THAMES CROSSING ACTION GROUP

As a group we remain strongly and completely opposed to the proposed Lower Thames Crossing.

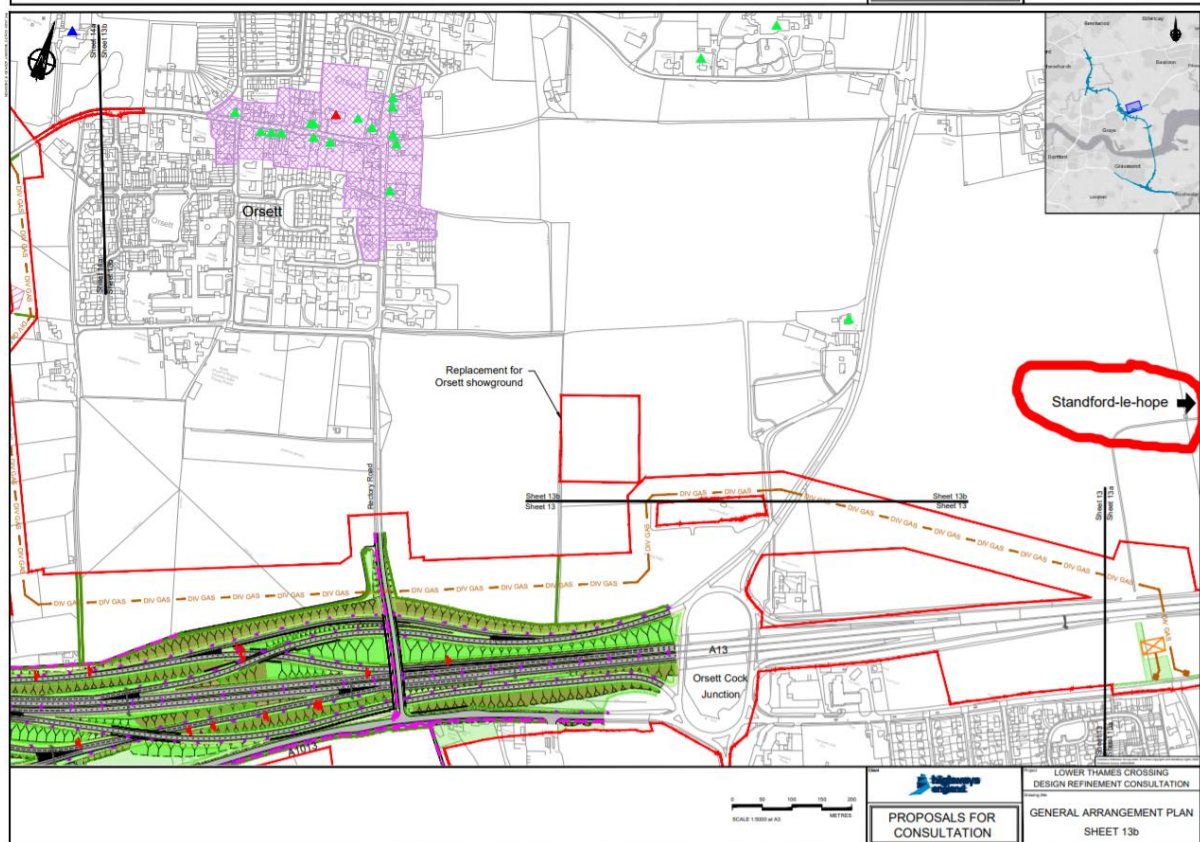
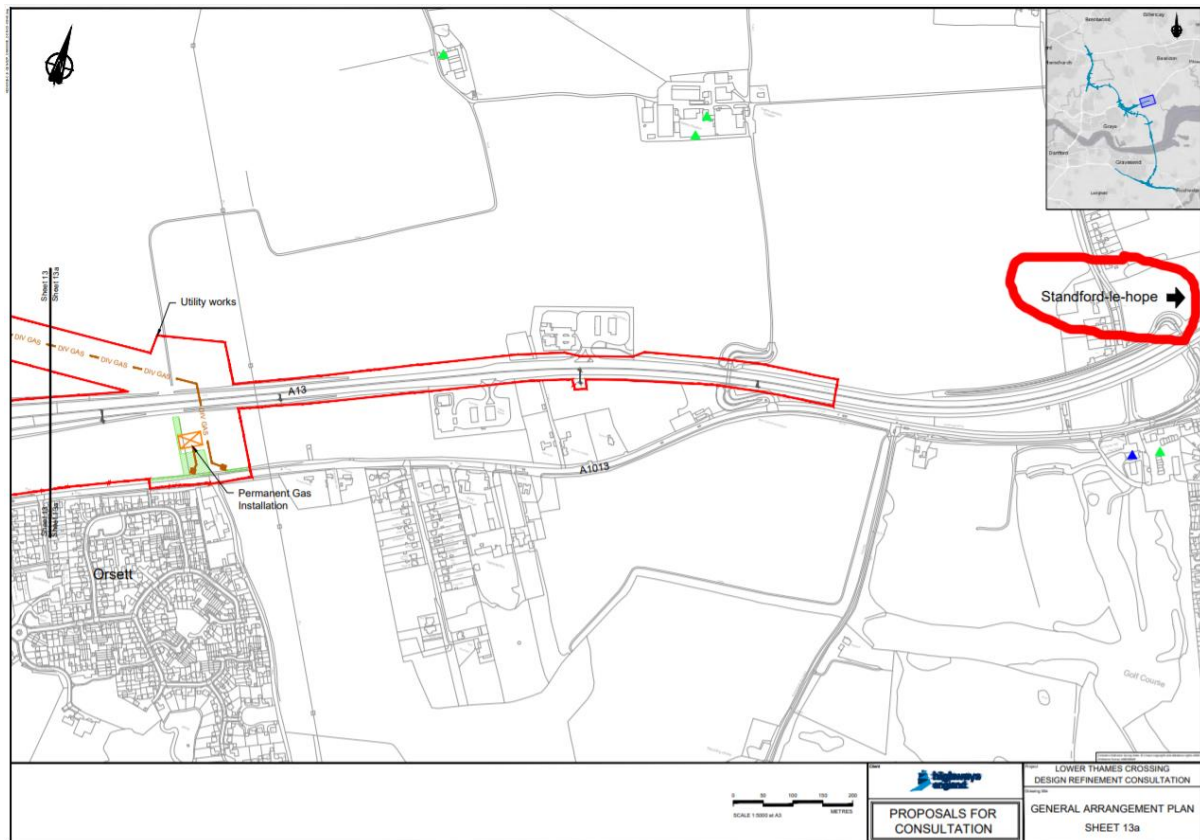
In Map Book 2, Sheet 13a you have misspelt Stanford-le-hope, adding a 'd' in the middle of Stanford, as can be seen in the image below. If you can't even spell the names of the local places what hope have we got and what trust can we have in you. Clearly you don't even care enough to ensure that place names are correctly spelt. It's not like we haven't mentioned the Stanford Detour to you enough times! If errors like this are made it gives us absolutely no confidence at all that you will ensure that other details are correct either, and when you're talking about such a large and damaging project costing £8.2bn+ that is a serious concern.

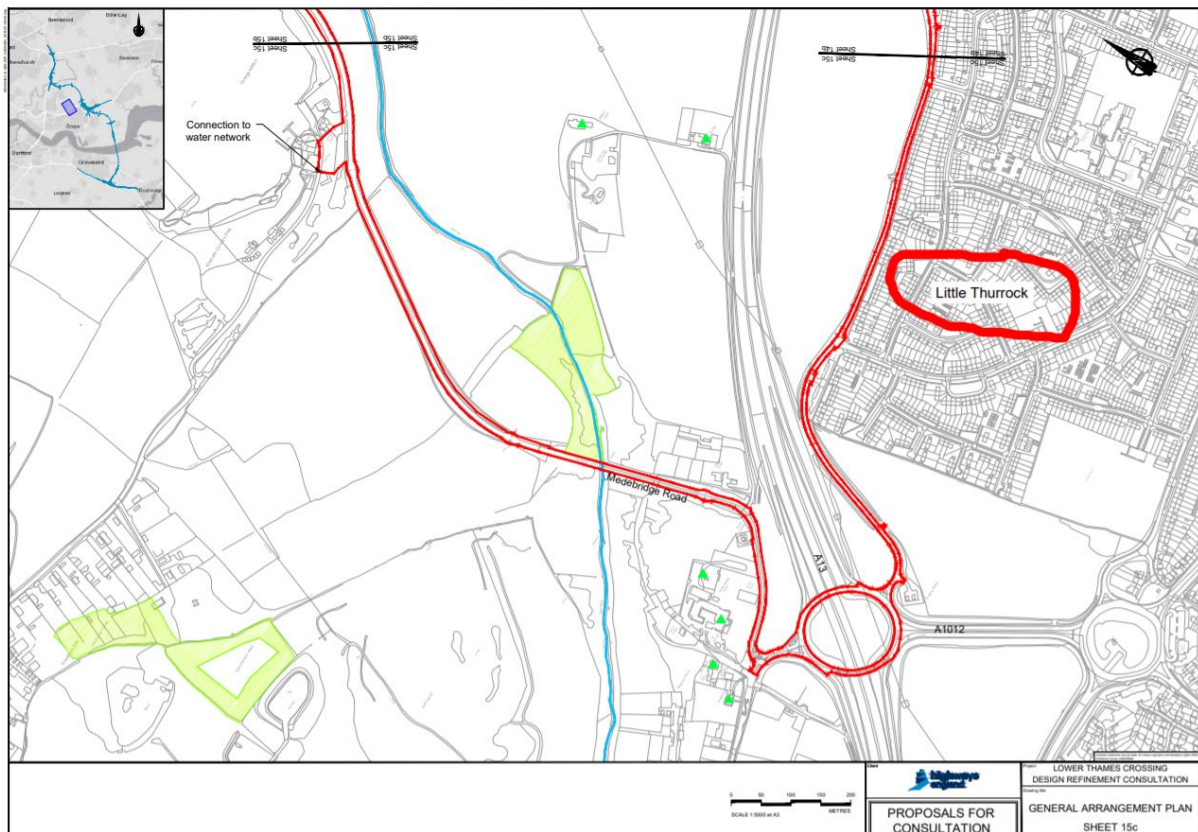
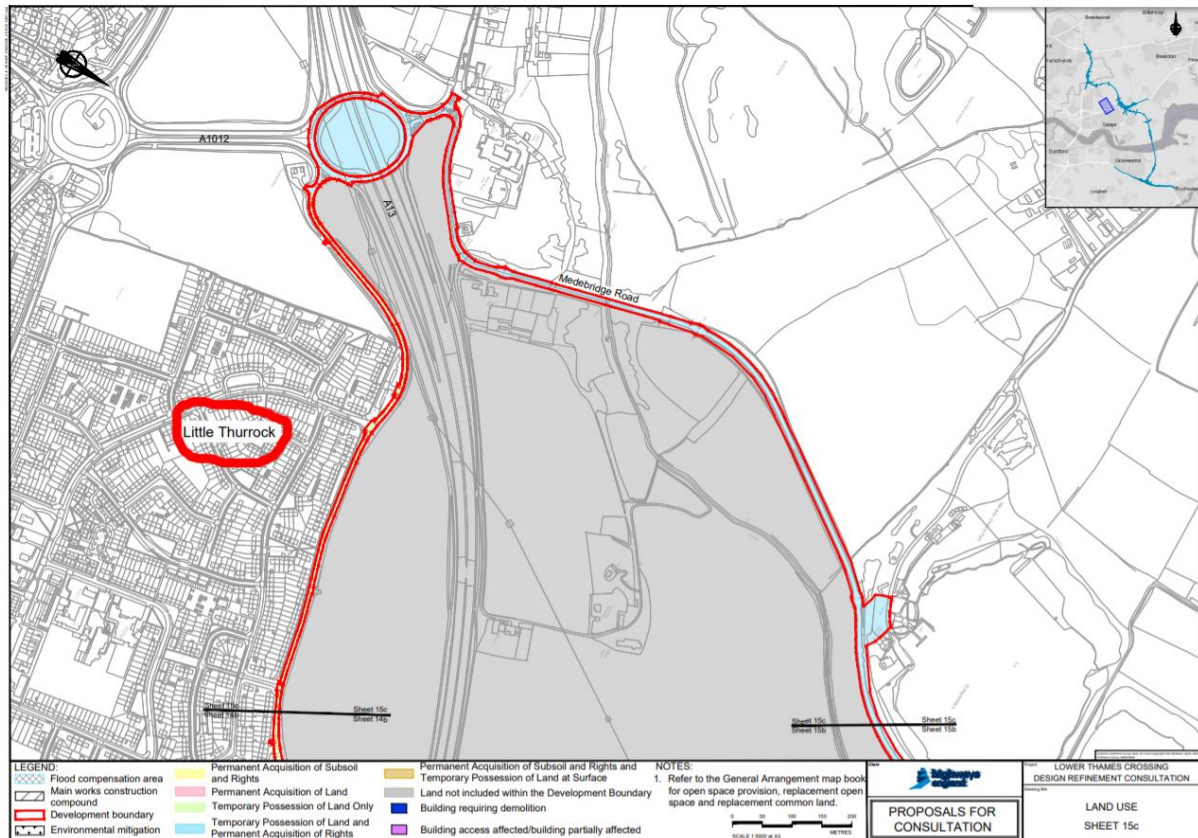
This was not a one off, as it was also repeated in Map Book 1 on Sheets 13a and 13b. Shown in the images below.

We also find it surprising and confusing that you have labelled Stifford Clays as Little Thurrock in Sheet 15c in both Map Book 1 and Map Book 2.. We know many would have struggled to figure out which area this map was supposed to be covering. Plus if anyone was trying to look through the Map Books to find reference to the Stifford Clays area they most certainly wouldn't be looking for Little Thurrock. Another example of your lack in local knowledge, and lack of care over attention to detail, and ensuring that the info you provide us is clear and adequate.

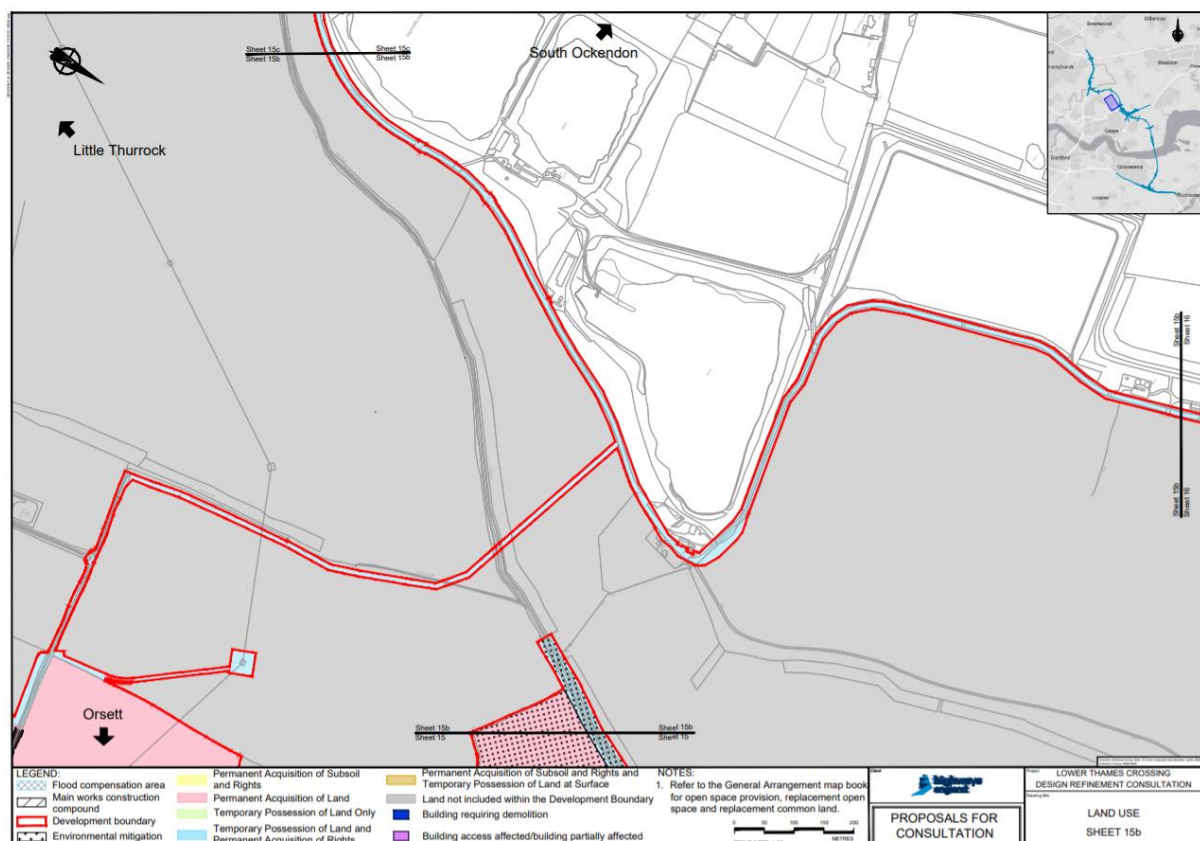
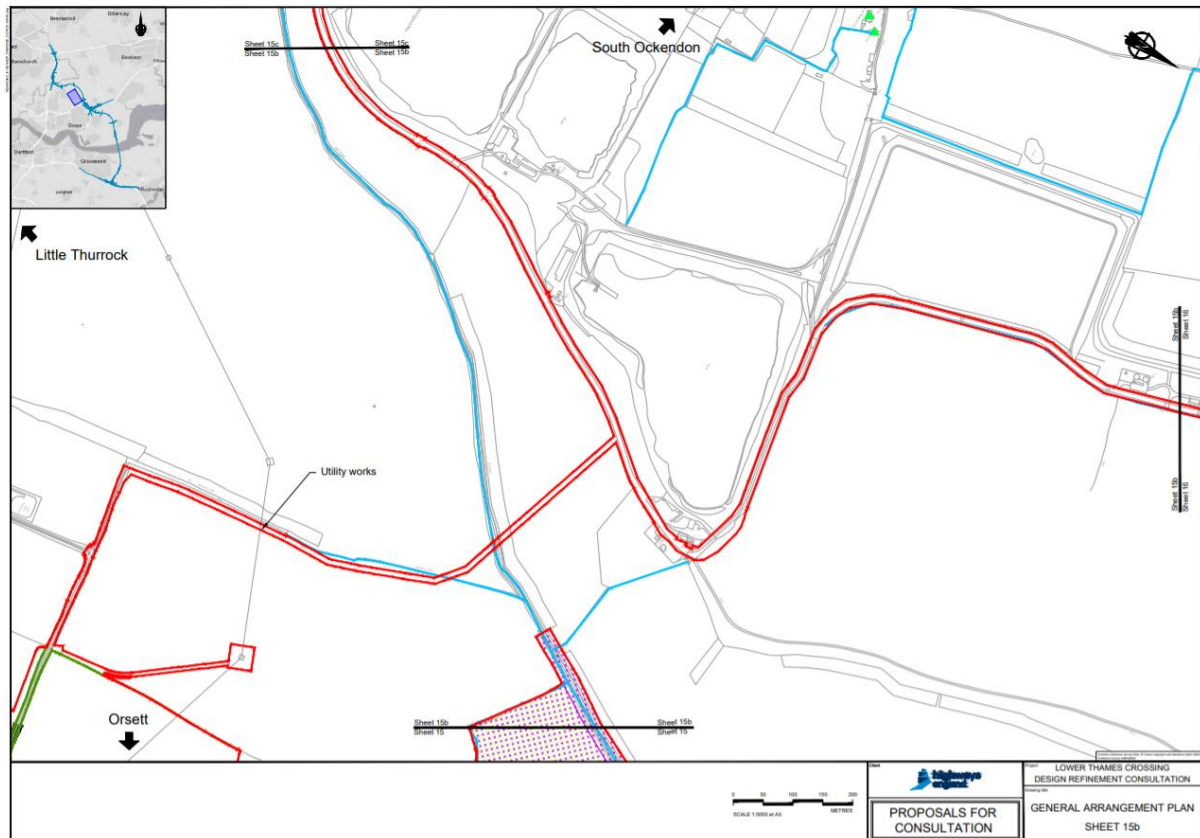
As you can see from the images below taken from the Map Books, this is also another perfect example of how confusing it is that you rotate the orientation of the maps, so North faces a different direction practically every page, and isn't even consistent when showing exactly the same area between Map Book 1 and Map Book 2

That then leads us on to Sheet 15b in both Map Book 1 and Map Book 2 where again we can only assume you are referring to Stifford Clays but are yet again labelling it as Little Thurrock. Considering the lack of real labelling, as you simply use arrows to point in the directions of places, and one of these as we state is incorrectly labelled it makes the map very difficult to understand. As can be seen in the images below. We suppose that we should be grateful that at least north is facing the same direction in both these maps, but then again it's another example of North not facing up as most people as used to when viewing maps.

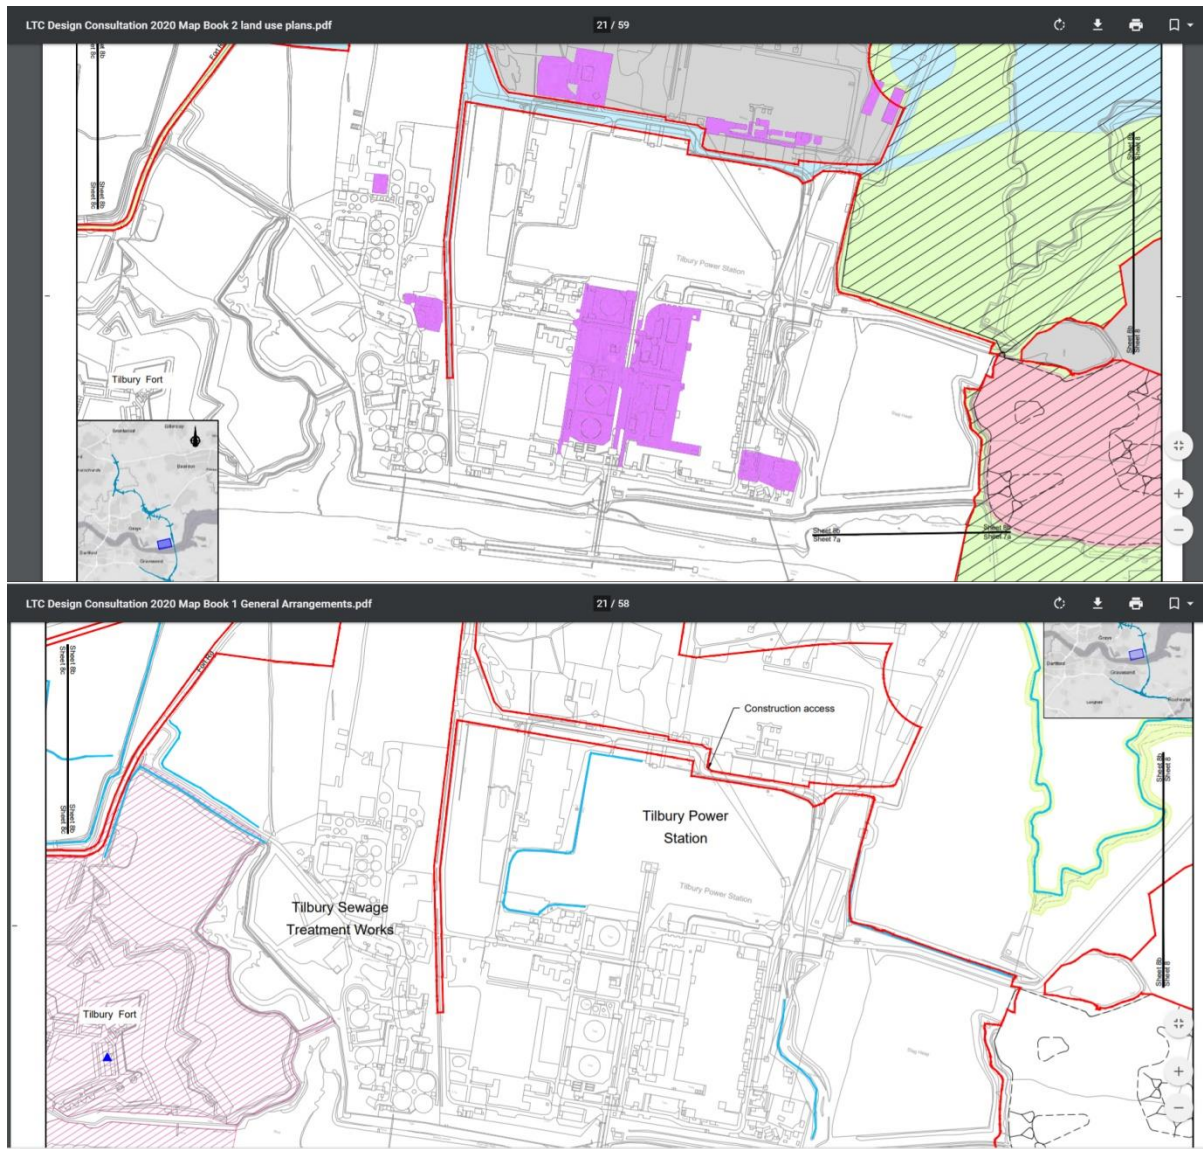
Map Book 2 is also labelling and showing the foot print of Tilbury Power Station which closed and was demolished between 2016-19. Tilbury 2 is being constructed yet it is not shown at all in any of the maps. The map is labelled Tilbury Power Station and shows the footprint of the power station as though it is being acquired, as can be seen in the images below. Using out of date map info is not acceptable, clear or informative.

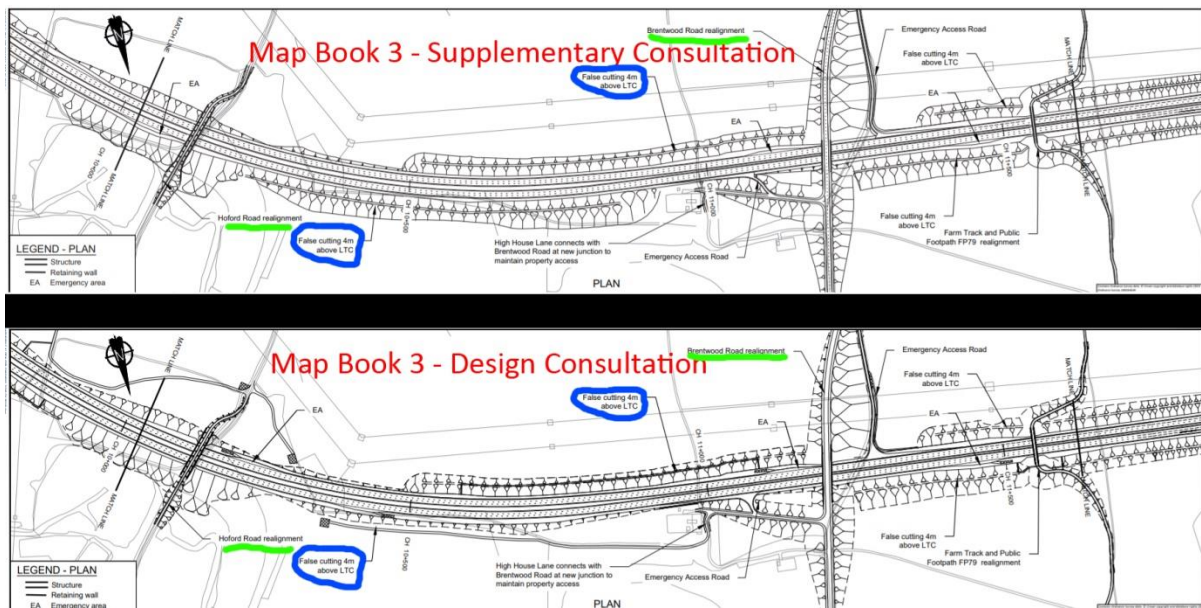
We have marked Brentwood Rd and Hoford Rd labelling (*underlined with green*), and also circled the mentions of false cuttings between those two points (*circled in blue*), for ease of reference.

If the false cutting is being removed why has at least one of the false cutting references in the plans not been removed? This doesn't make sense at all, and we believe this to be another error. If not then it certainly isn't clear or informative. If you say something is being removed there should be a visual change of something being removed in the plan, not the same references to false cutting in both versions of that section.

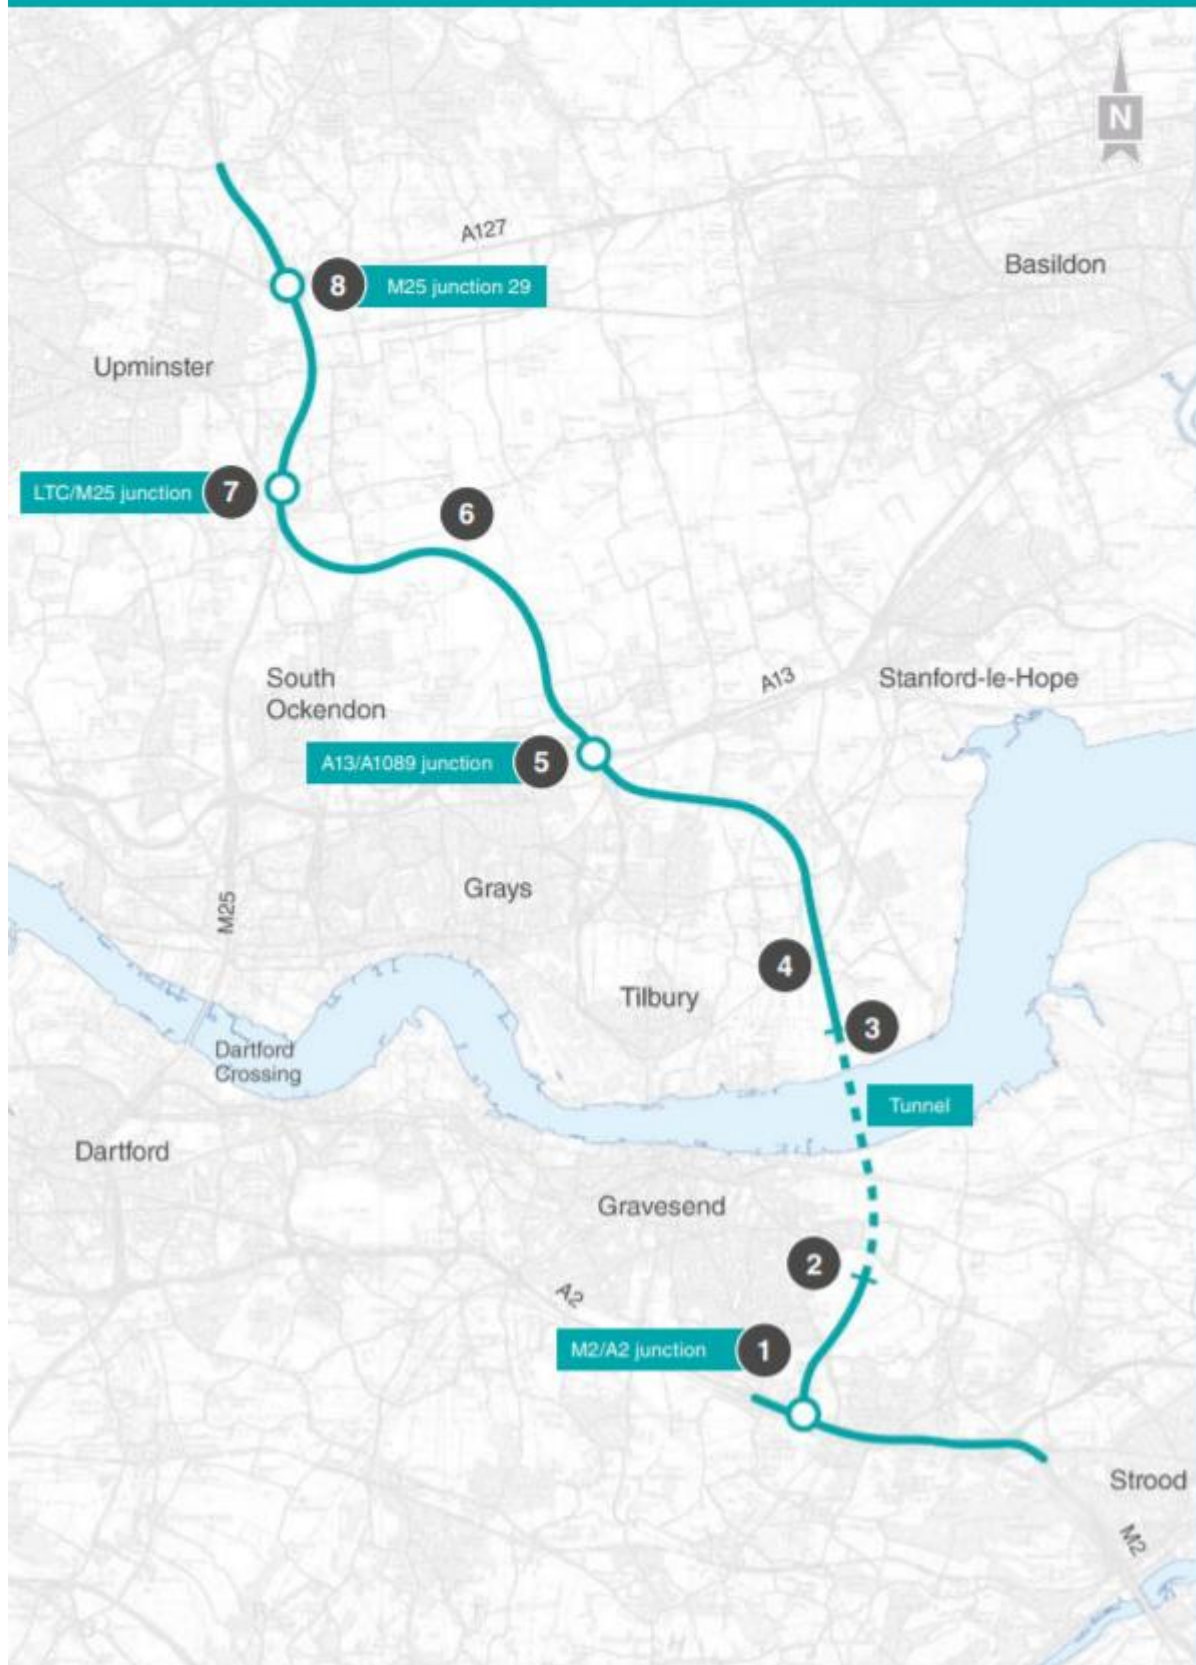
Not only that but still during this consultation throughout various maps in the guide the images being used still show the route only going as far north as Warley Rd, and not all the way up to J28 on the M25. If it is classified as being in the development boundary as land permanently acquired then it should be shown as the LTC route in all maps in our opinion.

This point is highlighted in maps like the one below, which is used numerous times throughout the guide
